Standing Rock Sioux Tribe

**Call for the Shutdown of the
Dakota Access Pipeline
and
Comments on the Army Corps of Engineers'
Draft Environmental Impact Statement**

December 13, 2023

Figure XI.4. Lake Oahe Geographic Response Plan (2018) Control Point #1 Compared to Satellite Imagery (4-8-22).

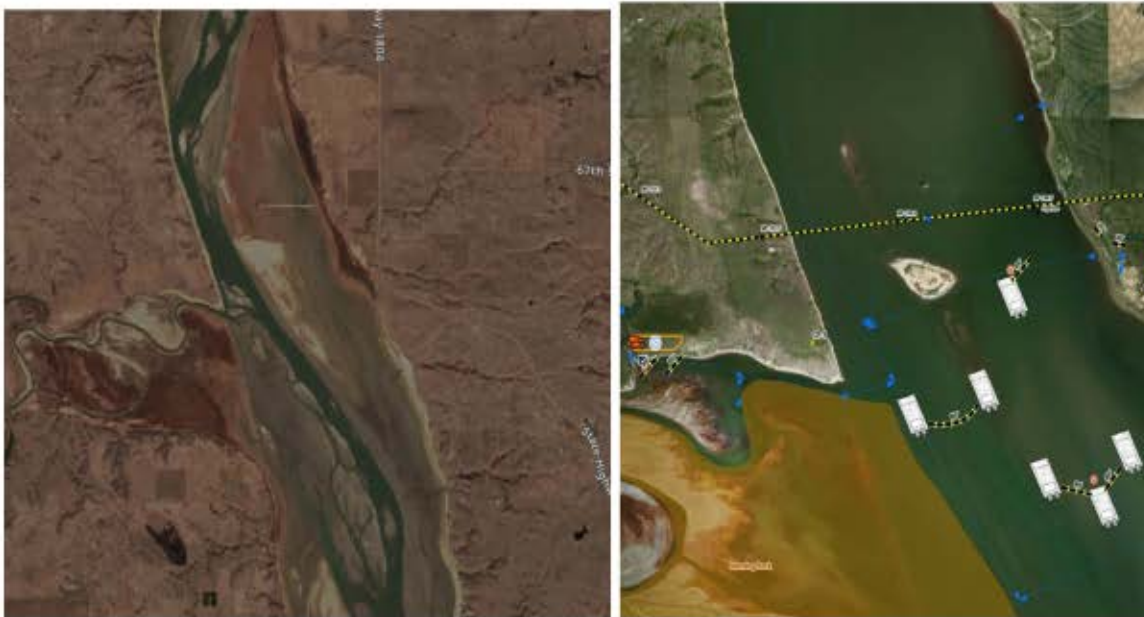
The Control Point 1 (CP-1) area just downstream from the DAPL undercrossing is the most critical for accessing Lake Oahe near the source of a DAPL spill and engaging in spill mitigation before greater volumes of oil can travel downstream and more seriously impact water intakes and the environment. Figure x.3 compares the CP-1 area from satellite imagery to Energy Transfer's GRP¹⁶¹ and the severely braided water in Lake Oahe nearest the DAPL undercrossing. Energy Transfer's GRP requires significant boat and skimmer travel from boat ramps to their identified oil spill Control Points. The upper Control Points areas in Lake Oahe are now in most cases exposed river bottom. Identified locations for vacuum trucks and tanks on the north bank of the Cannon Ball River used for oil clean-up are now distant from the braided water and unusable.

Figure XI.5. The Lake Oahe boat ramps designated for access to response Control Points such as Fort Rice and Beaver Bay have been unusable during severe low water. North Dakota Game and Fish, Boat Ramp Access, Lake Oahe, Website captured 2022.

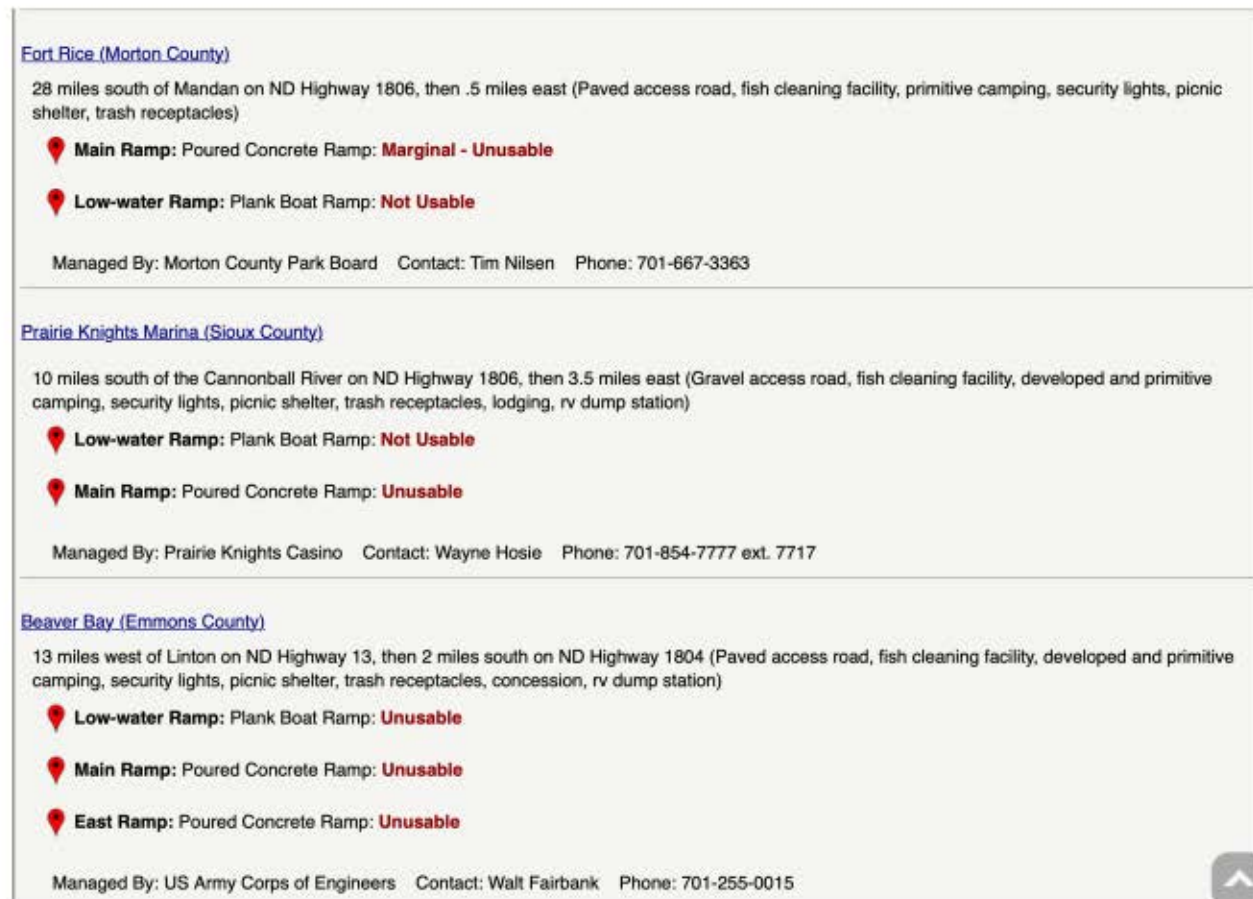
The Corps has responded to these issues with unsupported assertions of feasibility and claims of equipment availability not in the company owned inventory of staged emergency response equipment. The low water listed equipment is labeled as external with no location provided implying the equipment will need to be procured in the event of a spill. Lake Oahe boat ramps in the vicinity of the response control points during the low water crisis have largely unavailable (Figure x.4).

The Corps baldly declares “improved boat ramps on Lake Oahe should be capable of allowing access even in conditions matching the lowest known water levels at Lake Oahe. In the event that water levels decrease to the point whether improved boat ramps are inaccessible, the inaccessibility of the boat ramps will not inhibit the viability and timeliness of emergency response

Figure A-13. Time history of total hydrocarbon concentration for the 95th percentile unmitigated FBR scenario for surface oil exposure at the Lake Oahe pipeline crossing location, drinking water intake 13.

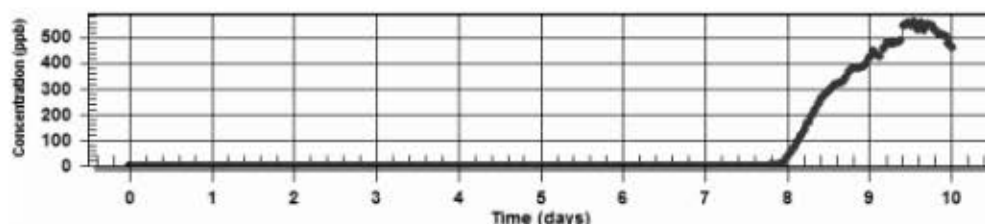
Energy Transfer's oil spill modeling is incomplete which is not addressed by the Corps. All of the model simulations in the three oil spill modeling reports track the movement of oil for 10 days following the hypothetical spill. Additionally, the study boundary for the model simulations is terminated at 74.67 miles downstream of the Lake Oahe crossing. This is just before the SRST drinking water intake (intake #14, at 75.41 miles downstream). Given the SRST's high level of concern surrounding possible contamination at the SRST drinking water intake, the intake should have been included in the model domain. Despite not being included in the model domain, the DEIS concludes in Section 3.3.1.3¹⁸⁸ that the SRST intake "was not predicted to be impacted within the 10-day period under any modeled scenario."

In the oil spill modeling report, time series of subsurface oil concentrations show substantial concentrations of oil at intake 13 at the end of the 10-day model simulation. For example, see Figure A-13 of the report, reproduced below, which shows the subsurface concentration of total hydrocarbons peaking just before the end of the simulation. The oil spill modeling report also concludes that it may take 10 days for contaminants to initially reach intake 11 (one of the three downstream intakes where subsurface concentrations were analyzed in more detail).¹⁸⁹ A longer simulation duration would have provided more details about the ultimate fate and transport of the spilled oil, impacts on downstream receptors, as well as areas where resurfacing of entrained oil would be more likely.
